RE: NSTAR Electric Company d/b/a Eversource Energy and New England Power Company  
d/b/a National Grid, EFSB 15-04/D.P.U. 15-140/15-141

COMMONWEALTH OF MASSACHUSETTS  
ENERGY FACILITIES SITING BOARD  
DEPARTMENT OF PUBLIC UTILITIES

EFSB 15-04/D.P.U. 15-140/15-141

Information Request Set 1  
Response to NSTAR Electric Company  
d/b/a Eversource Energy and New England  
Power Company d/b/a National Grid  
September 12, 2016  
Person Responsible: Richard Howard

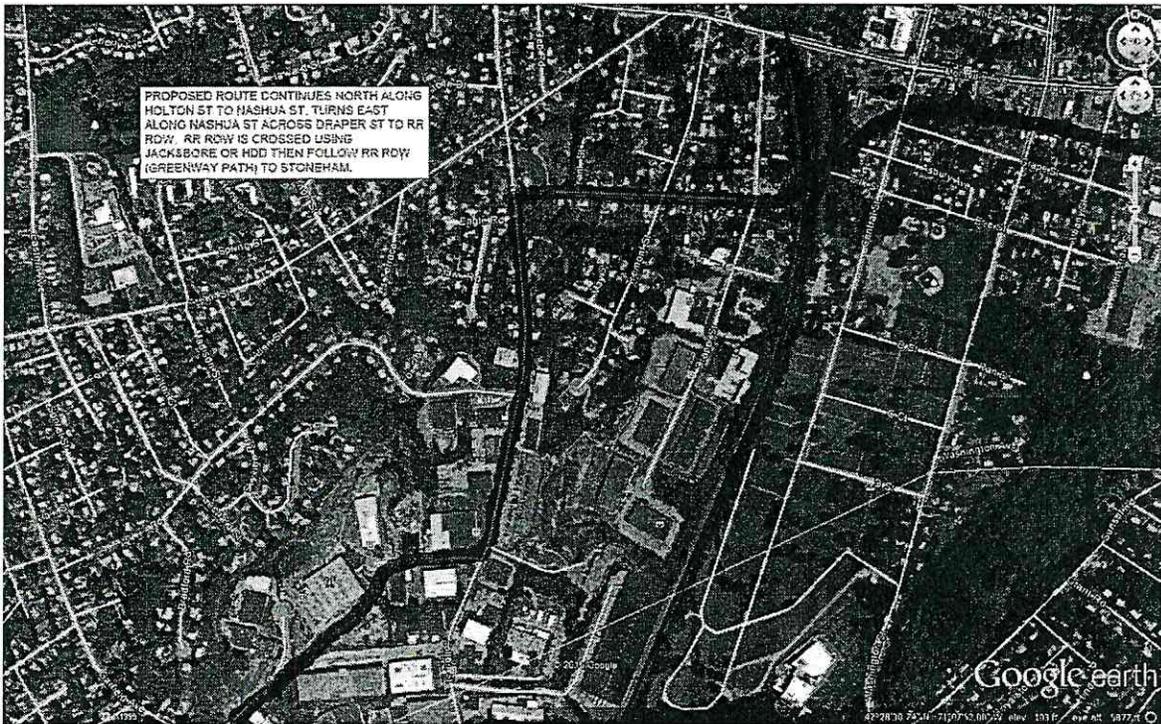
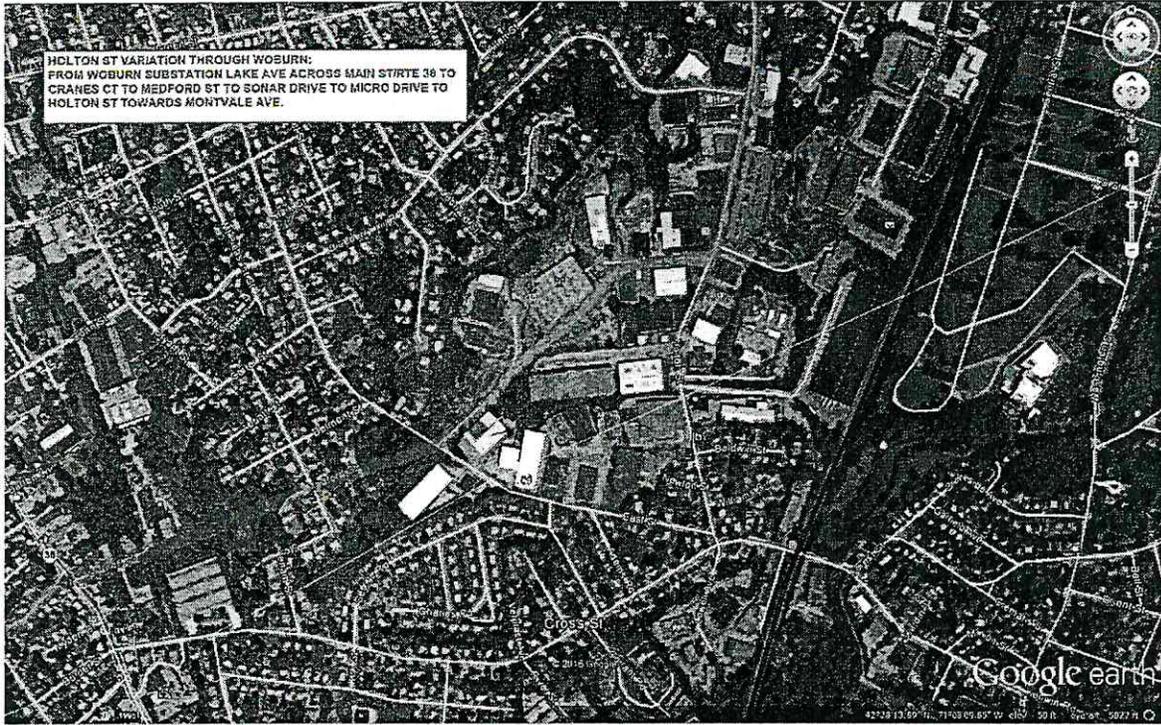
See attached plans proposed route layout between Lake Ave and Holton Street:

Along Holton St to Nashua St across the active RR ROW using Jack&Bore or HDD to continue along inactive RR ROW to be used as the Tri-Community Greenway continuing to Stoneham's portion of the Tri-Community Greenway.

This route provides the following advantage or reductions in impact of the various criteria:

- Avoids Cross Street which includes one of the two Winchester Aberjona River crossings and a RR crossing.
- Avoids Green Street
  - Cross St and Green St are similar in width, traffic, residents, businesses, utility congestion and trees. By using this alternative route both are only crossed instead of being used as the longitudinal alignment proposed in the petition for the Preferred Route and the Noticed Alternative Route, respectively.

- The proposed route segment significantly reduces the count of residential units along the route, mitigating many issues by the sheer avoidance of many households and businesses.

- Although the crossing of the active RR line cannot be avoided by any route, crossing near Nashua Street eliminates the two Winchester Aberjona River crossings. An HDD crossing could cross both the RR and Sweetwater Brook which runs parallel to the RR. The added advantage is that it is in an area where there is no traffic and few utilities.

See Attachment TOW-RS-2(1)

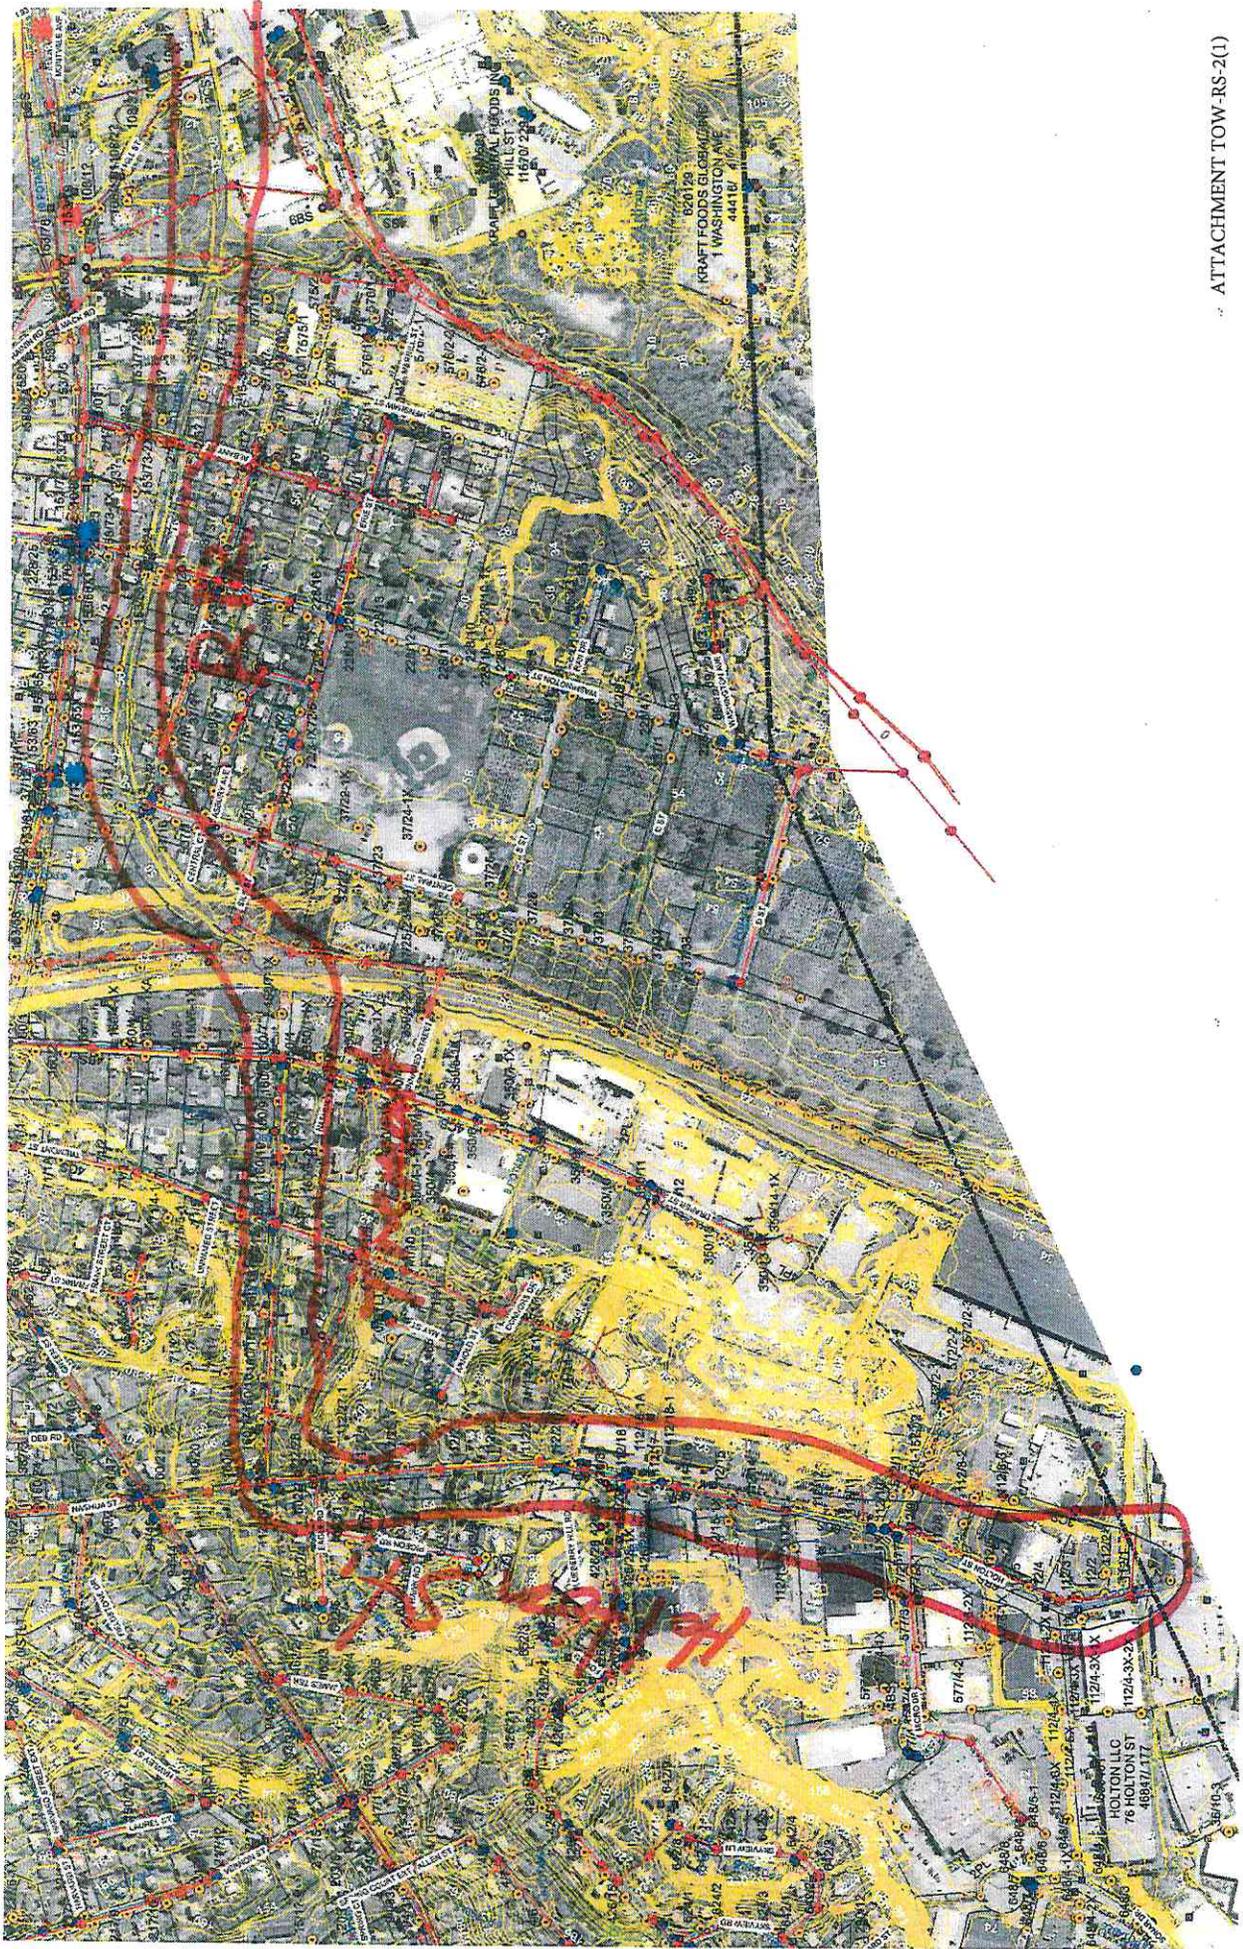
The Town of Winchester and the City of Woburn have held several meetings on a proposed alternative route through Woburn which reduces the impacts of the Environmental Justice Areas described in TOW 3. The proposed Route is attached as Exhibit B and runs up Holton Street and then through largely commercial areas of Woburn.

Assuming that both Winchester and Woburn support this alternative will the Companies provide an environmental constructability analysis of this alternative?

Please see the Companies' response to Information Request CUR-1-1(a), as well as Attachment CUR-1-1(a)(1), for an analysis of why the use of Holton Street is inferior to the Companies' already proposed Green Street Variation of the Preferred Route.
